Appendix H: FRNSW FEBQ Response

Request for Consultation - Alternative Solutions Fire Engineering Brief Questionnaire

Version	Author	Organisation	Content	Date
V1	Ulf Johansson	RED Fire Engineers	For review and comment	19th of February 2016
V2	Matthew Rowley	FRNSW	Response to FEBQ V1	06/04/16
V3	Ulf Johansson	RED Fire Engineers	Response to FRNSW comments	27/05/16

Smoke compartments on Ground Floor

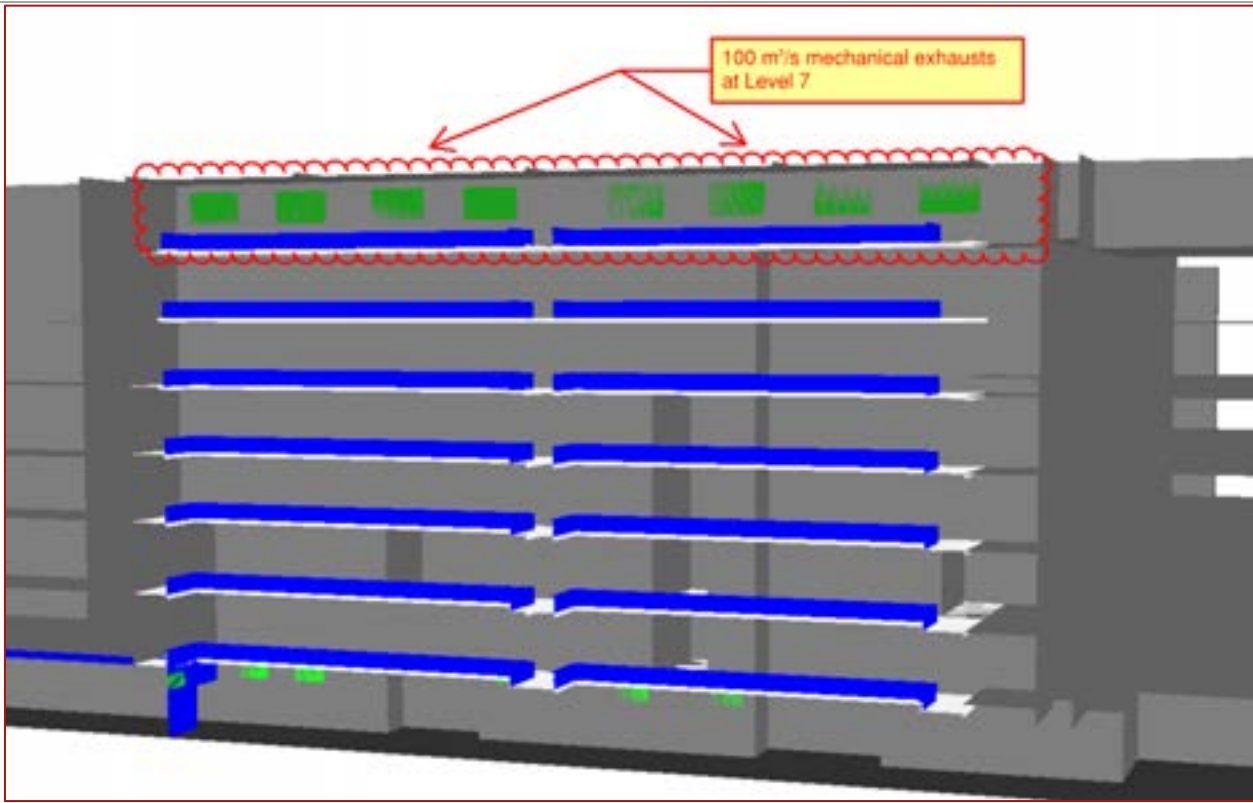
FRNSW comment: As discussed in the FEBQ meeting, please provide further explanation on how the Zone Smoke Control system will operate in conjunction with the atrium smoke exhaust system. This should consider different fire scenarios, e.g.1) smoke detected in atrium, 2) smoke detected in a ward, 3) or smoke detected in atrium and in ward compartment simultaneously.

Proposed location of mechanical smoke exhaust on Level 7

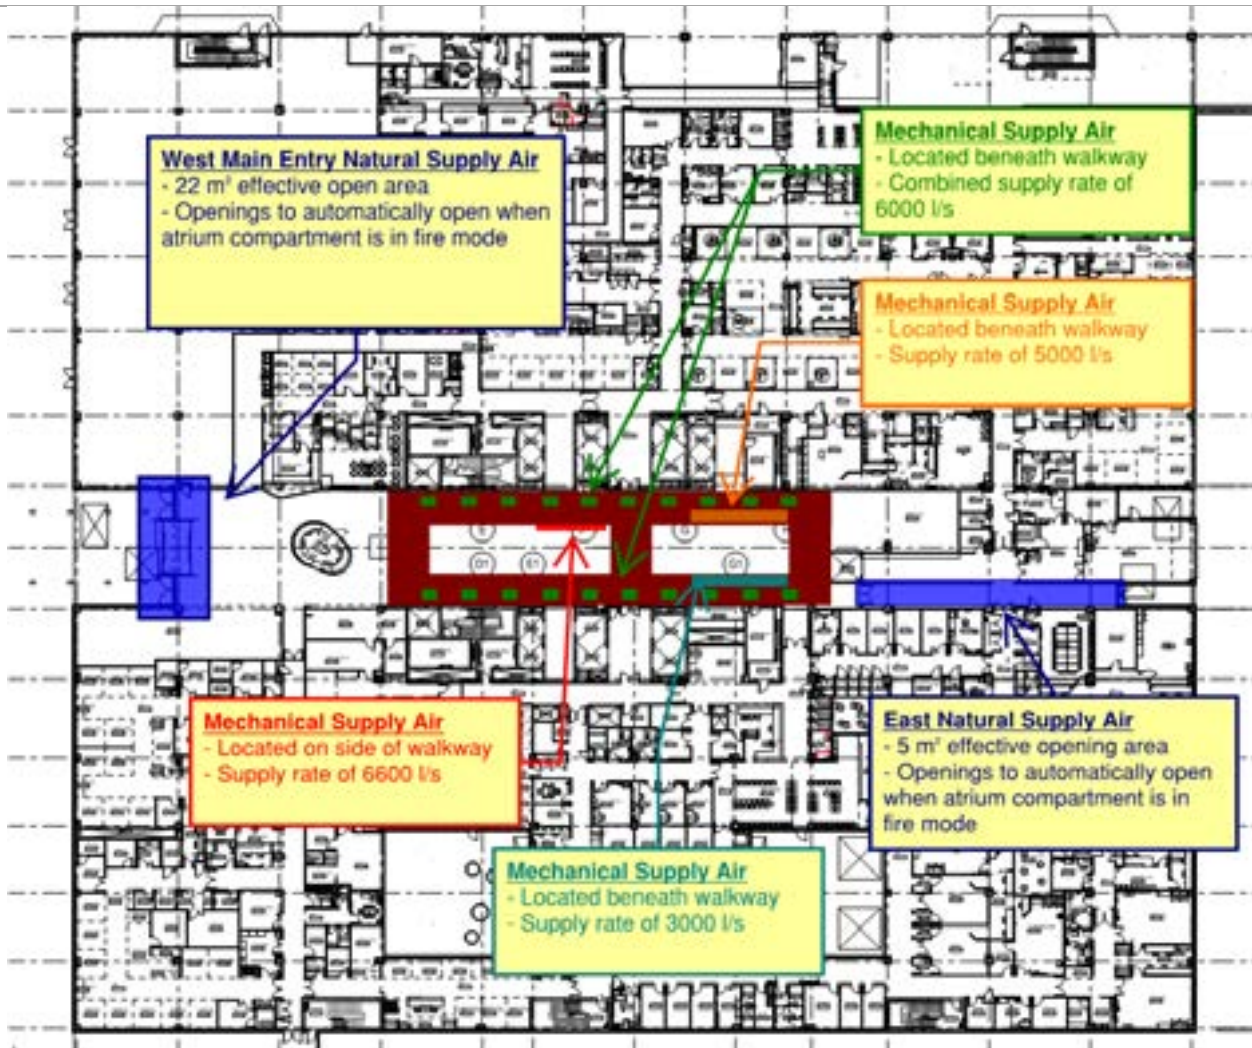
FRNSW comment: The submitted CFD form states that the sprinkler system will activate the exhaust, which goes against what is stated above. This should be clarified in the FER (of Version 3 of the FEBQ, if applicable).

RED: The statement that the sprinkler system will activate the bespoke smoke exhaust system is incorrect. Only smoke detection system will active this system. This will be clarified in the FER.

Figure 3.10 in AS 1668.1-1998

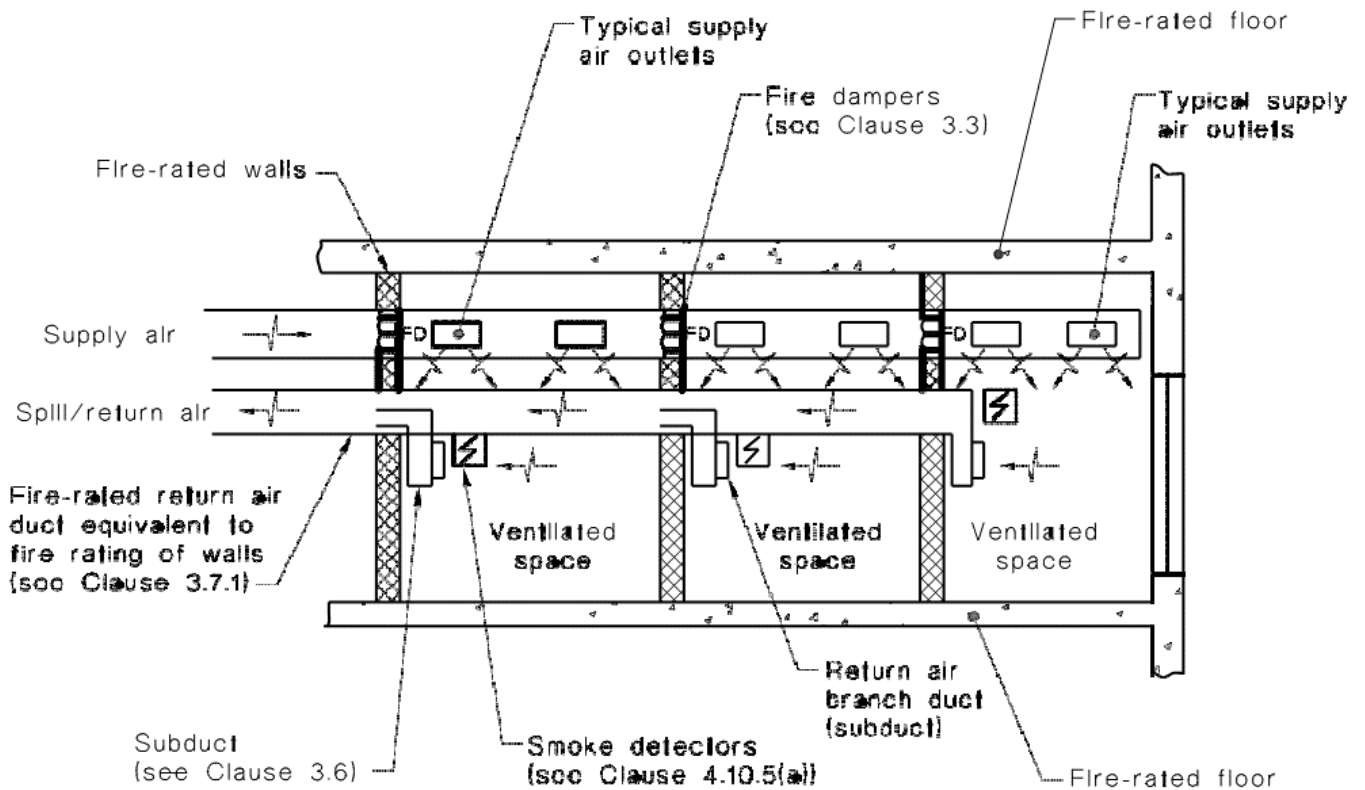
FRNSW comment: It is FRNSW current position that we do not support the use of motorised dampers in lieu of subducts, **at the return air/smoke exhaust shafts**, within new buildings, due to concerns that motorised dampers cannot achieve an equivalent level of reliability. FRNSW are of the view that subducts, being a passive system, with little to no maintenance requirements offers a higher level of reliability compared to an active damper system that is dependent on power supply, mechanical and electrical components and maintenance.

RED: The intent of sub-ducts is to provide protection against smoke spread in the event of the fan being in exhaust mode during a fire fails due to high temperatures. The sub-ducts together with the natural buoyancy of the hot gases in the ducts will limit spread of smoke and fire between compartments and floors to the degree necessary as required by AS 1668.1-1998. Where smoke spill risers extend to serve multiple compartments on a single floor, sub-ducts need to be provided in accordance with Figure 3.10 in AS 1668.1-1998 (see figure below). Fire dampers are not permitted on ducts provided with sub-ducts but air-control dampers are permitted. Normally such air-control dampers are closed to non-fire affected compartments and opened to fire-affected compartments in an AS 1668.1-1998 compliant design of zone smoke control systems. The failure position of such air-control dampers is 'open'.

In the proposed design, the sub-ducts as shown in Figure 3.10 in AS 1668.1-1998 are replaced by motorised fire dampers without fusible links. The motorised fire dampers to the smoke spill shafts are to be in a closed position during normal operation. For a fire-affected compartment, the motorised fire damper(s) open. All other fire dampers on smoke spill/return air ducts are to be closed. The motorised fire dampers are to be fail-safe in a closed position. The failure modes of the proposed solution are therefore as follows:

It is therefore RED's view that the solution above meets the Performance Requirements.

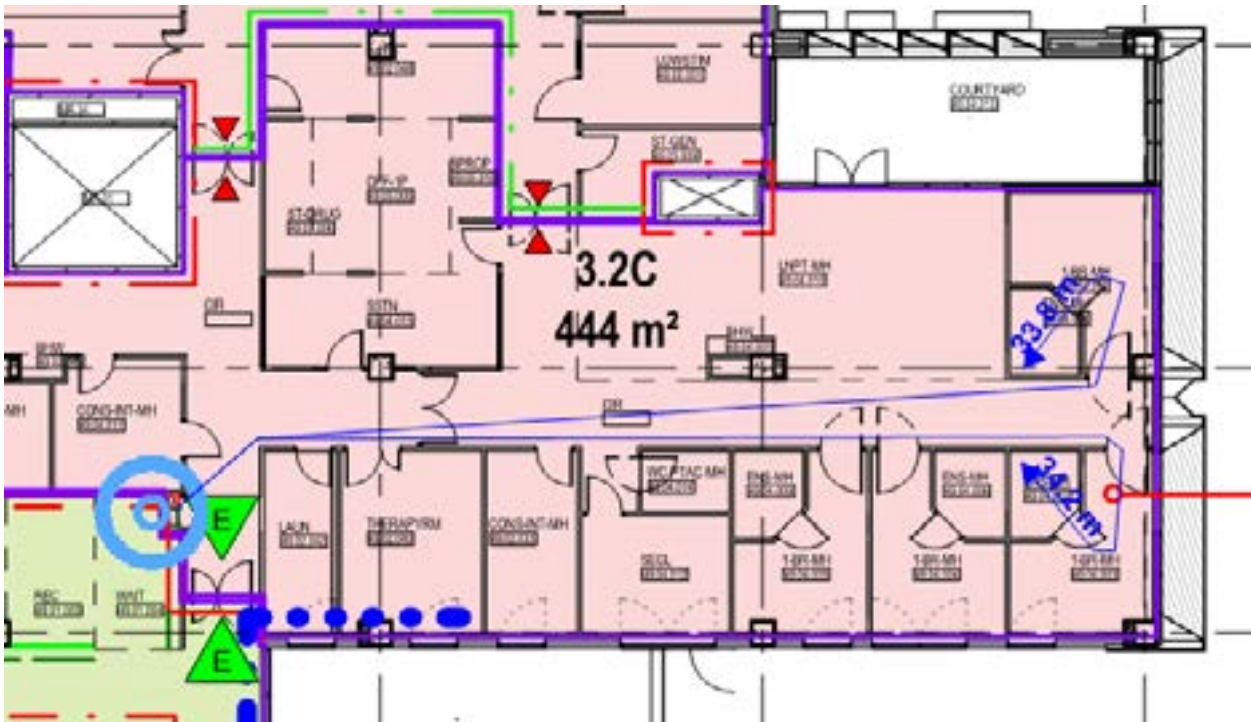
FRNSW Comment: Where a floor block plan is not located in accordance with Clause 2.2.5 of AS2118.6-2012, FRNSW recommends that a floor specific block plan be installed adjacent to the internal fire hydrants located within the fire isolated stairwells. The sole purpose of the block plans is to locate the *additional* internal hydrants on that level. The plans should be a minimum of A3 in size and be orientated to reflect the floor plate as being viewed facing the door with a "YOU ARE HERE" note

RED: Block plans to illustrate additional hydrants to be provided within fire stairs where this is required to achieve coverage.

Additional signage adjacent to the block plan in the stair stating that the *additional* hydrant on the floor plate is locked by a 003 lock. (Allowing FF to find a key or get second hose ready).

RED: Description that additional fire hydrant and fire hose cupboard is accessible with 003 key will be provided as described above.

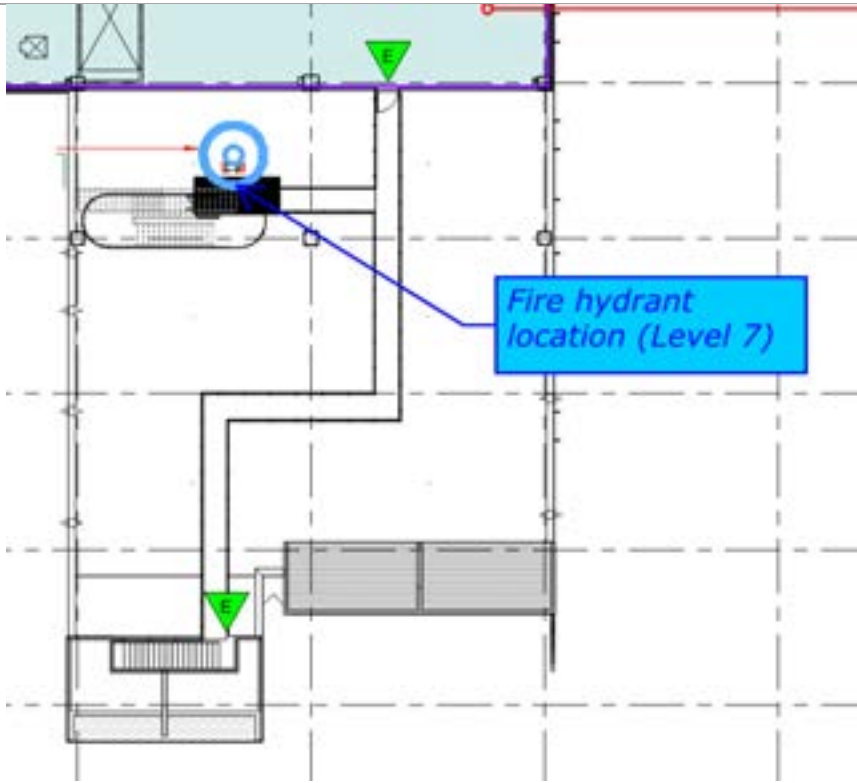
FRNSW Comment: FRNSW recommend the following should be detailed within the FER:

- How the shortfall in hose coverage will be addressed.
- What is the fire load in the areas

RED: This will be assessed in the FER.

Fire hydrant coverage from lift lobby on Level 8

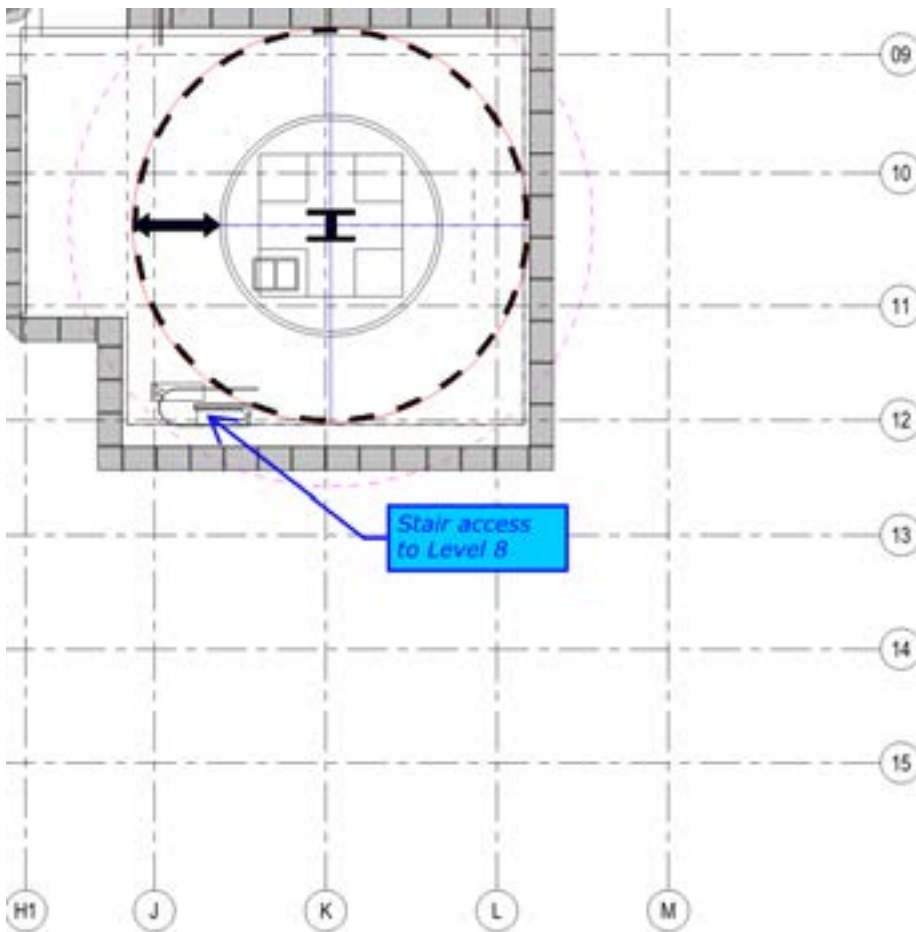
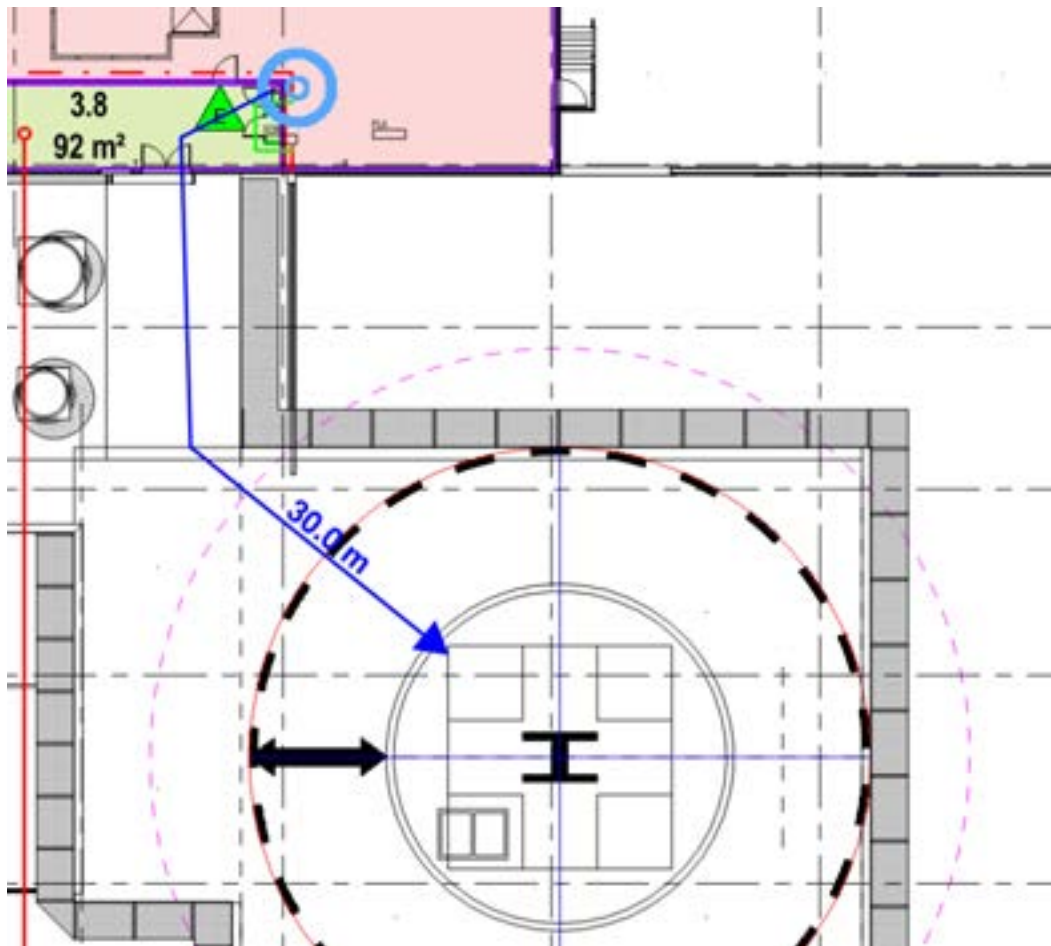
- FRNSW were advised at the meeting that there are two hydrant locations that can reach the helipad within 30m. Additionally there is proposed to be 50 L of foam to be provided. RED: Noted.
- FRNSW recommends that the location, type and quantity of foam be made available in the fire control centre through signage. RED: Noted.
- Additional fire safety measures and equipment such as the fire fighting foam required for the helipad be included in the Fire Safety Schedule, or, due to the application for Crown Building Works, please advise how all fire safety provisions will be documented and maintained (if differing to Clause 182 of the EP&A Regs). RED: Shall be included on ESM schedule.

In relation to the Helipad FRNSW provide the following comments for consideration:

- Details of the structure of the helipad to be provided in the FEBQ.
- The required design standards to be presented and referenced.
- FRNSW recommend the landing platform to be provided with a slight gradient to fall away from the hospital entry to prevent fuel spillage flowing into or towards the lobby;
- Bunding for the fuel to the capacity of the largest aircraft to use the facility;
- Run off through stormwater drains and containment within fuel/flame traps;
- Training of staff to deal with first response firefighting in jet fuel spillage incidents;
- Quantify the storage of portable foam extinguishing medium appropriate for the jet fuel capacity
